HISTORIC AND DESIGN REVIEW COMMISSION

HDRC CASE NO: 2019-032
ADDRESS: 112 E PECAN ST
LEGAL DESCRIPTION: NCB: 139 LOT: 15 NATIONAL BANK SUB UNIT-2
ZONING: D, RIO-3
CITY COUNCIL DIST.: 1
APPLICANT: Elizabeth Parks/RVK Architects
OWNER: Santa Clara Land Company, LTD
TYPE OF WORK: Expansion of the existing parking structure
APPLICATION RECEIVED: April 12, 2019
60-DAY REVIEW: June 11, 2019
CASE MANAGER: Edward Hall

The applicant is requesting a Certificate of Appropriateness for approval to construct an addition of two levels to the existing parking structure. The proposed addition will feature an architectural cladding system.

A-101
LEVEL 9 FLOOR PLAN

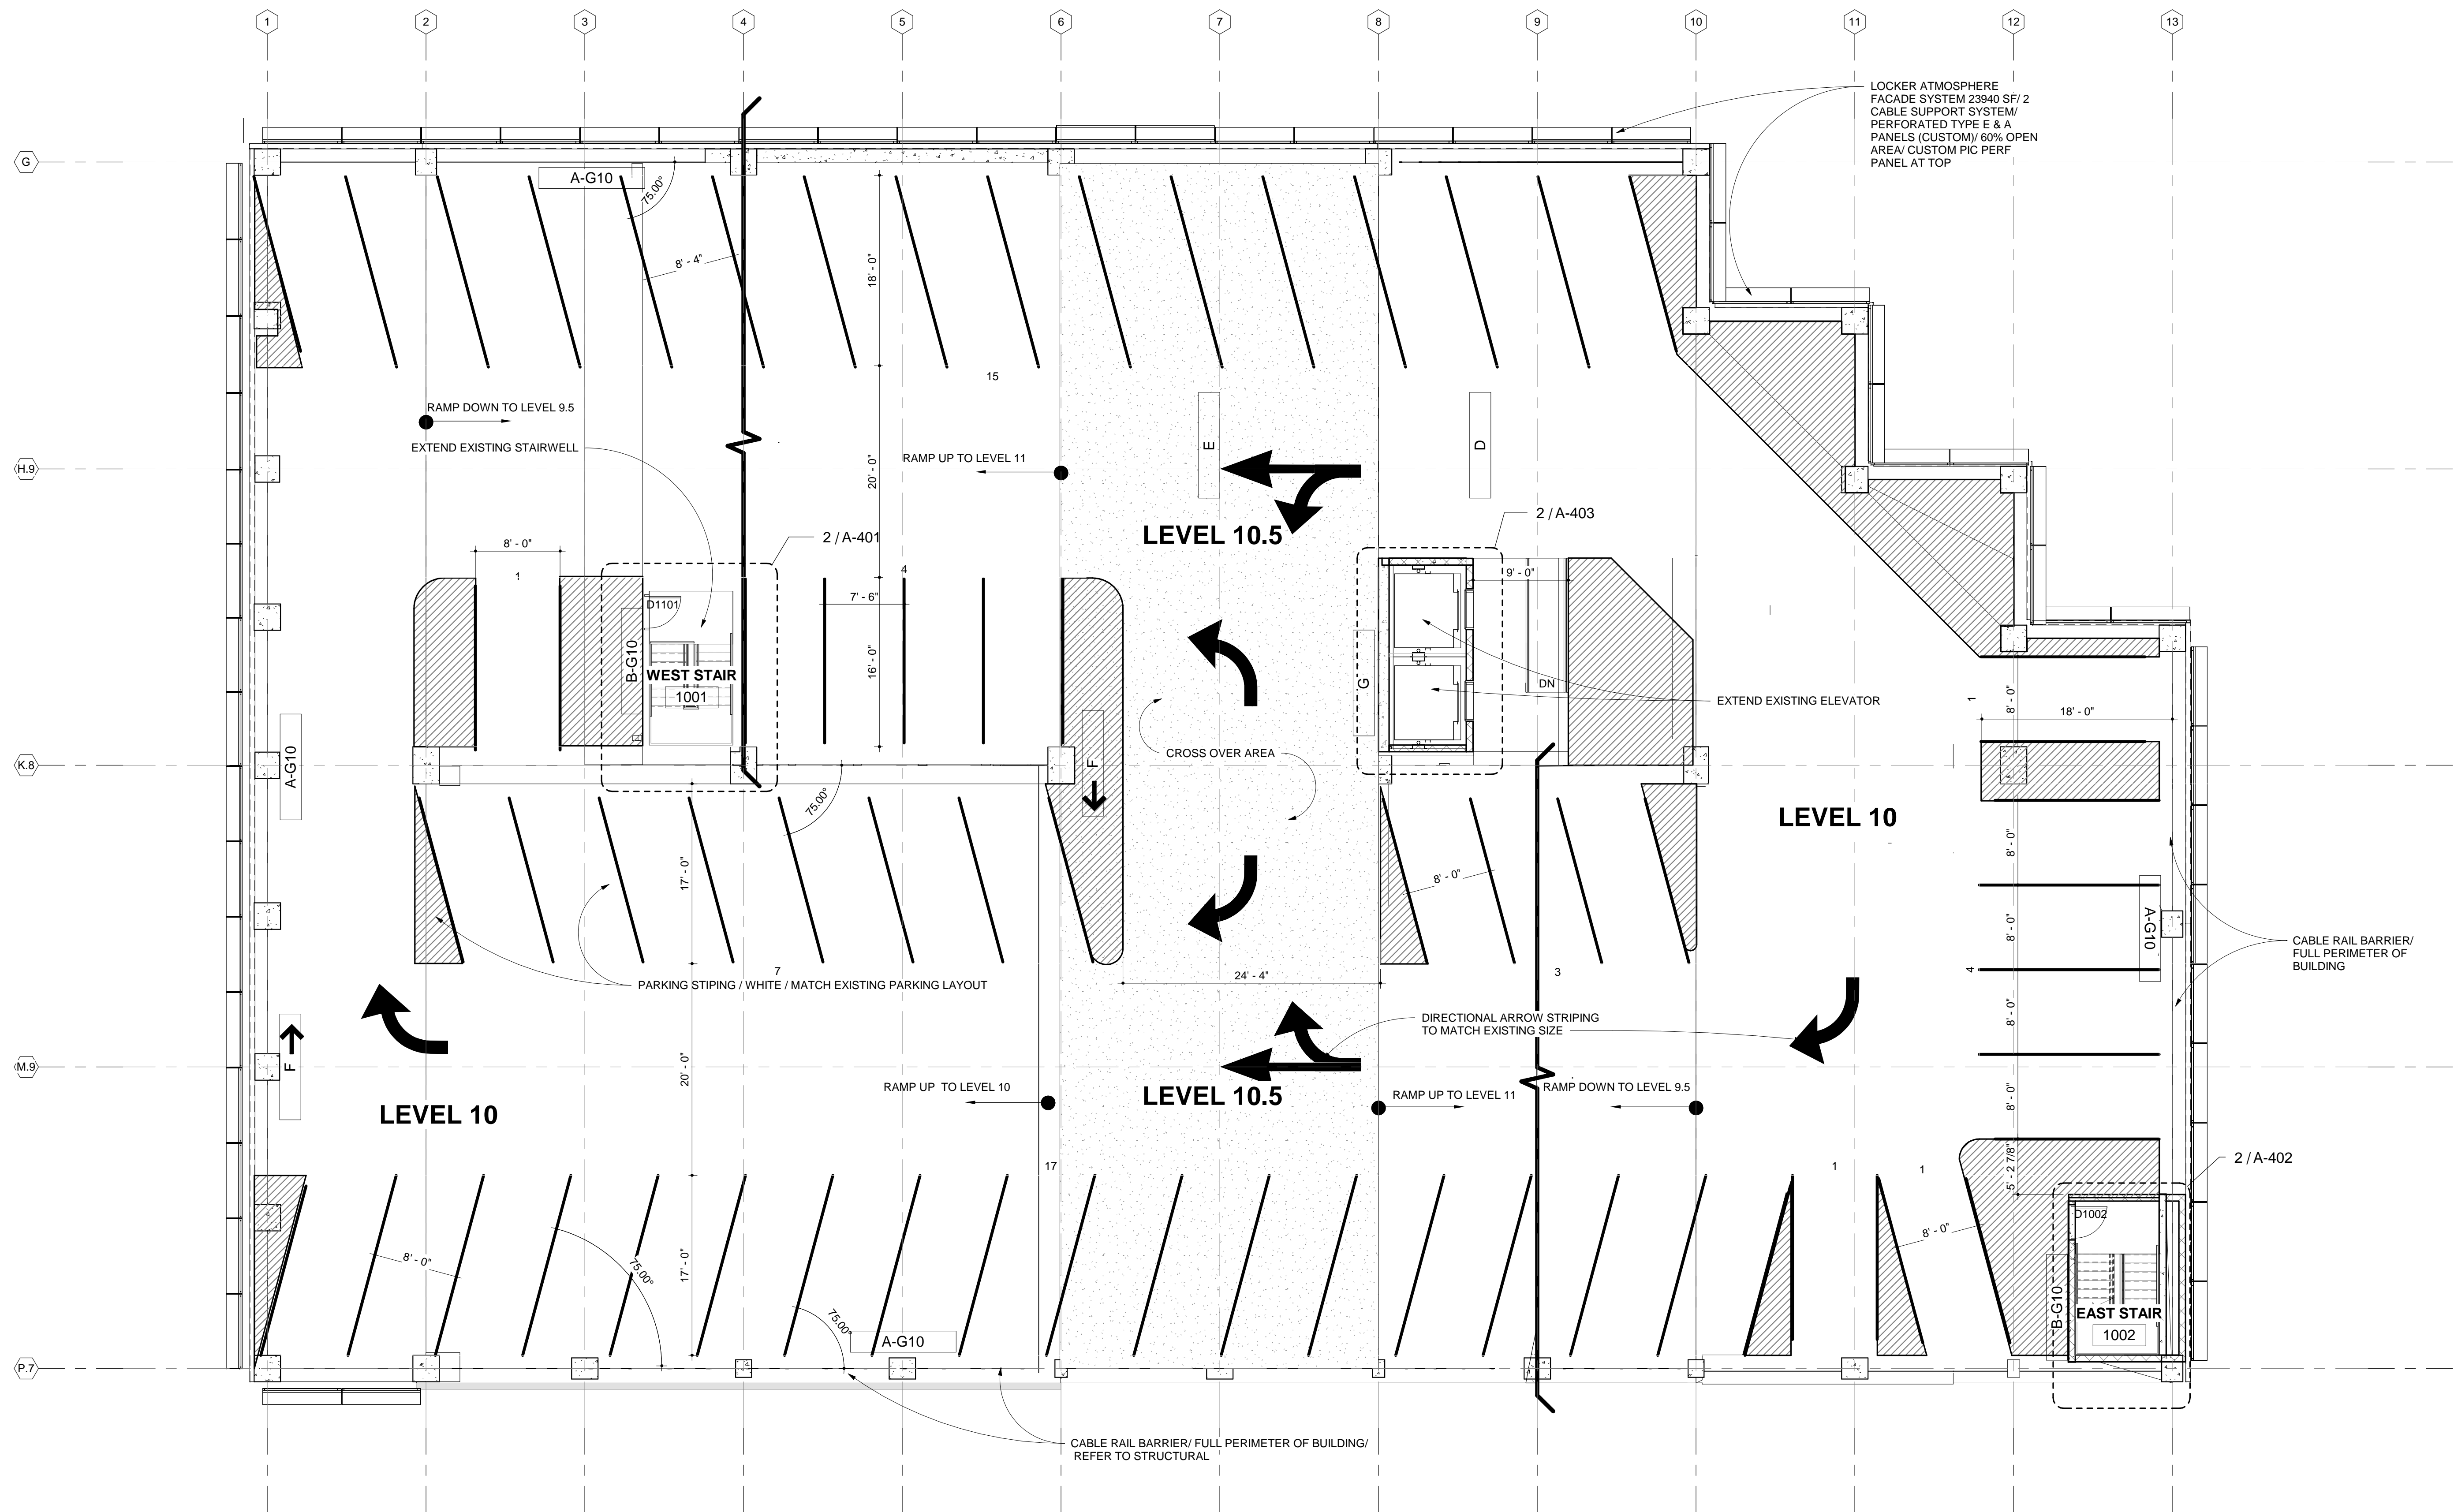
- f. **GARAGE CLADDING** – The applicant has proposed a cladding system that consists of perforated aluminum panels features both flat and bent panels that extend out from the structure. The applicant has also proposed a cladding system atop the previously described cladding system that features perforated aluminum panels that will consist of a picture. The proposed cladding will result in a translucent screen.
